PROPOSAL FOR DRAFT AMENDMENTS TO THE GTR ON PEDESTRIAN PROTECTION
(gtr No. 9)

(Document ECE/TRANS/180/Add.9)

A. STATEMENT OF TECHNICAL RATIONALE AND JUSTIFICATION

B. TEXT OF REGULATION

Figure 35: Test set-up for knee joint in static certification test (see paragraph 8.2.1.5.)

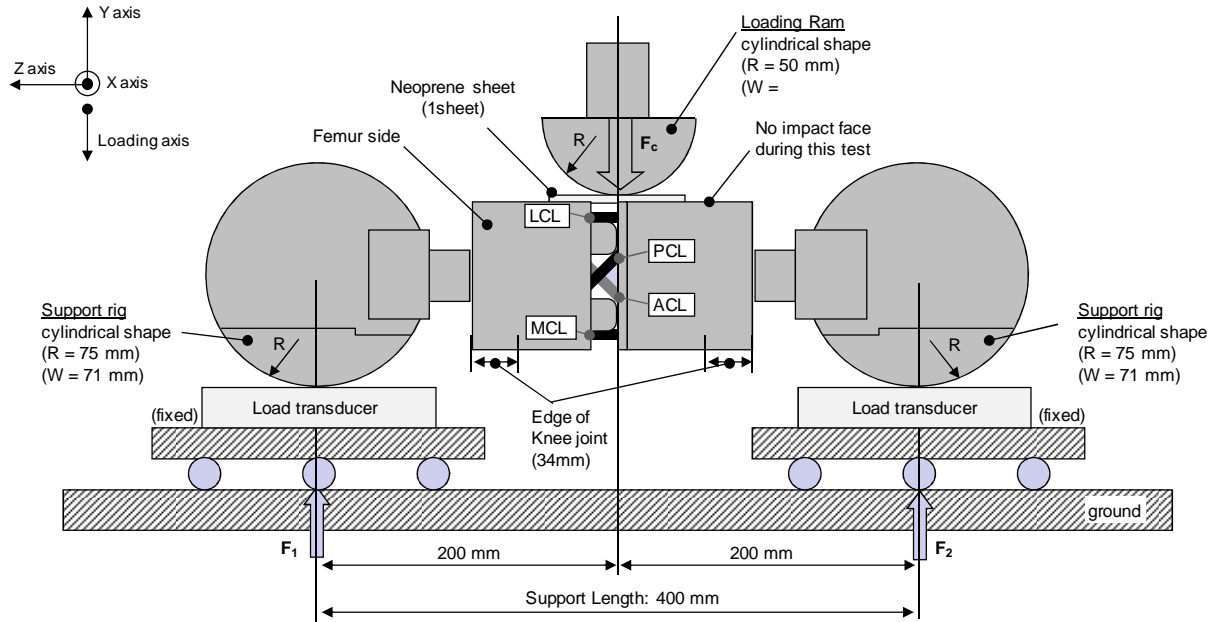
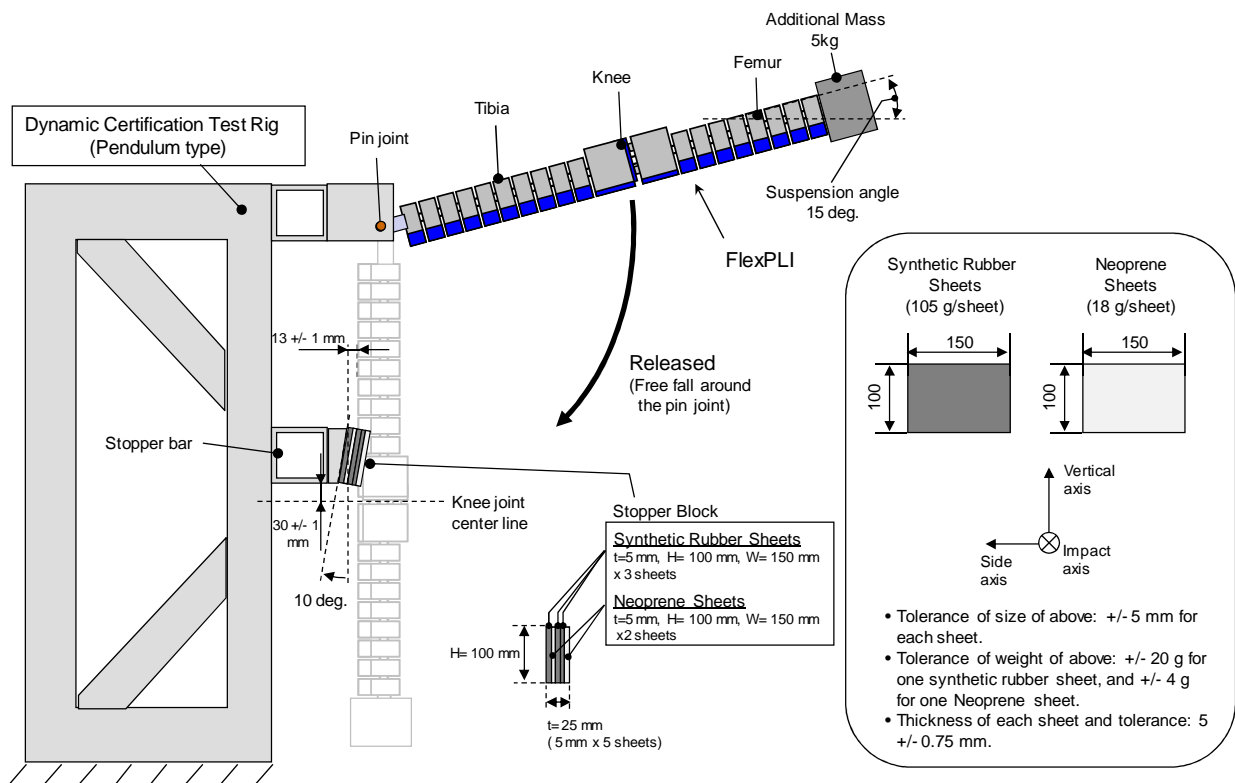
8.2.1.5. The edges of the knee joint, not bending parts, shall be mounted to the support rig firmly as shown in Figure 35. The Y axis of the impactor shall be parallel to the loading axis within $180 \pm 2^{\circ}$. In order to avoid friction errors, roller plates shall be set underneath the support rigs. To avoid impactor damage, a neoprene sheet shall

be set underneath the loading ram and shall be removed the impactor face of the knee joint which is described in the Figure 14. The neoprene sheet used in this test shall have compression characteristics as shown in Figure 16.

The centre of the loading force shall be applied at the centre of the Knee joint within $\pm [2]^\circ$ tolerance along the Z axis. The external load shall be increased at a rate between 10 and 100 mm/minute until the bending moment at the centre part of the knee joint (M_c) reaches 300 Nm.

Figure 37: Test set-up for stopper block certification test
 (see paragraph 8.2.2.4.)

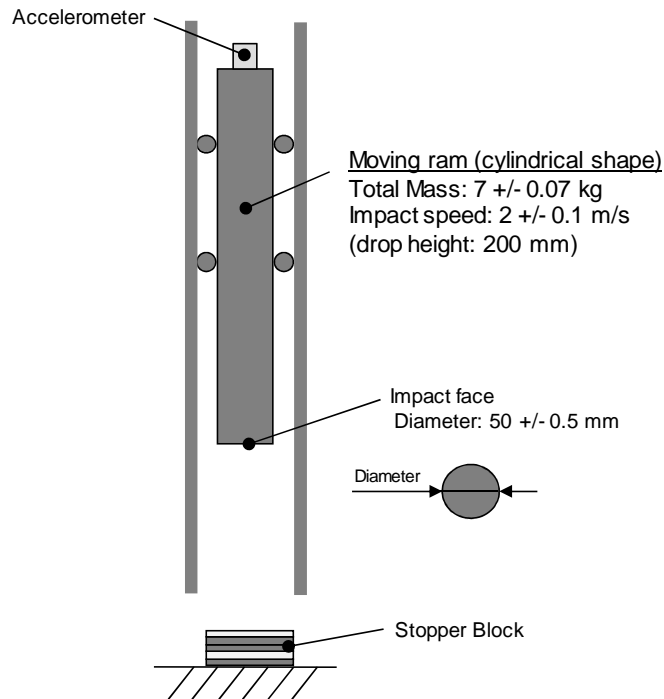
8.2.2.4.2. The stopper block, attached to the front of the stopper bar, shall have compression characteristics as shown in Figure 16 or shall generate maximum compression force from 3.5 to 4 kN when it is subjected to the drop test shown in Figure 37.

Figure 38: Test set-up for dynamic lower legform impactor certification test,

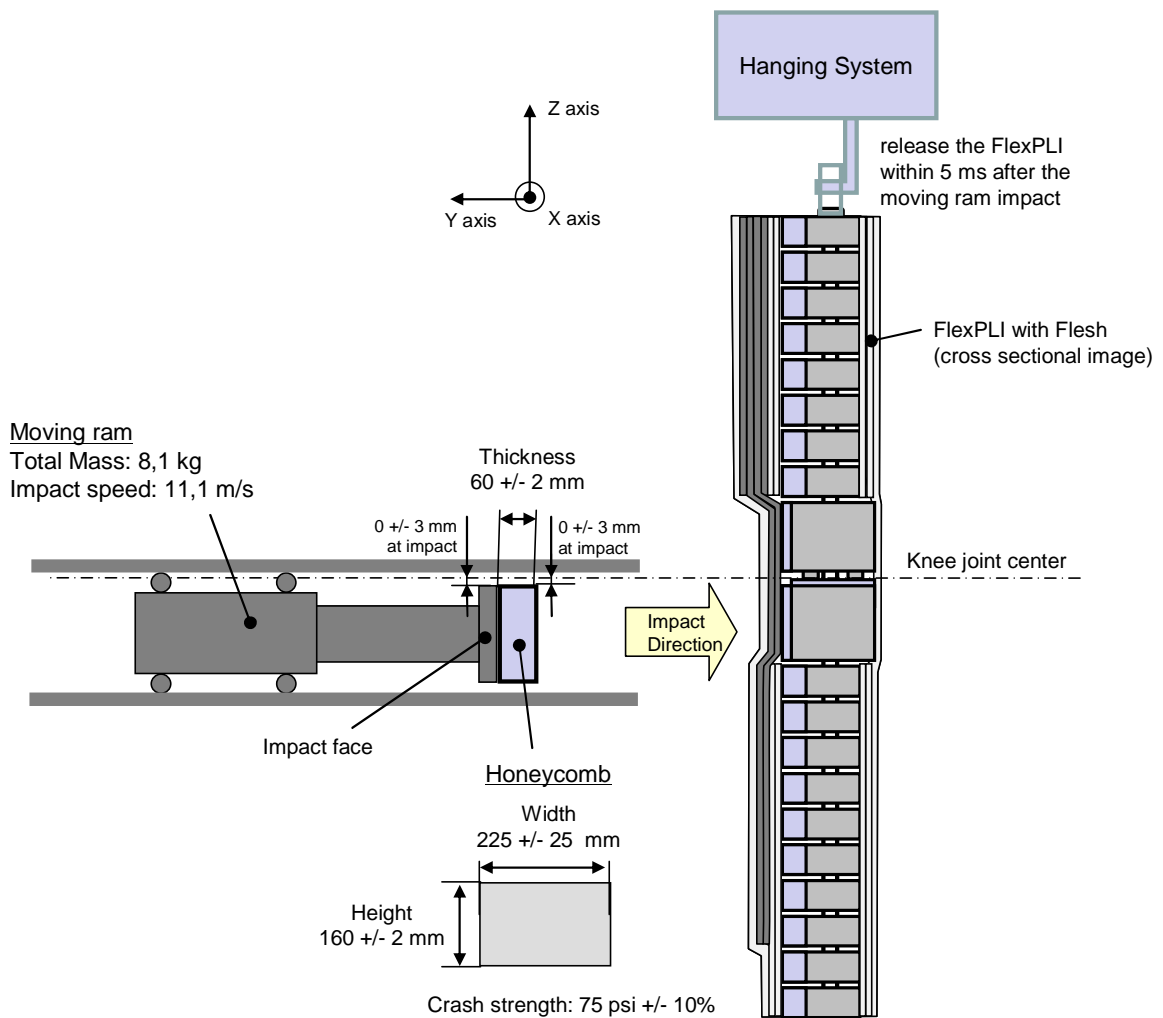
8.2.3.4.1. The impactor covered by flesh shall be hung vertically as shown in Figure 38. The impactor shall be impacted by a moving ram of 8.1 ± 0.1 kg mass, at an impact speed of 11.1 ± 0.2 m/s. The impactor shall be released from the hanging system within 5 ms after the moving ram impacts the impactor.

8.2.3.4.2. The honeycomb, which is attached in front of the moving ram, shall have a crash strength of 75 ± 7.5 psi, and it shall have the dimensions shown in Figure 38.

8.2.3.4.3. The honeycomb shall be set in front of the moving ram with its top line matching the knee joint centre line within a tolerance of 0 ± 3 mm along the vertical axis at the impact timing. The top line of the impact face of the moving ram also shall match the knee joint centre line within a tolerance of 0 ± 3 mm along the vertical axis at the impact timing.
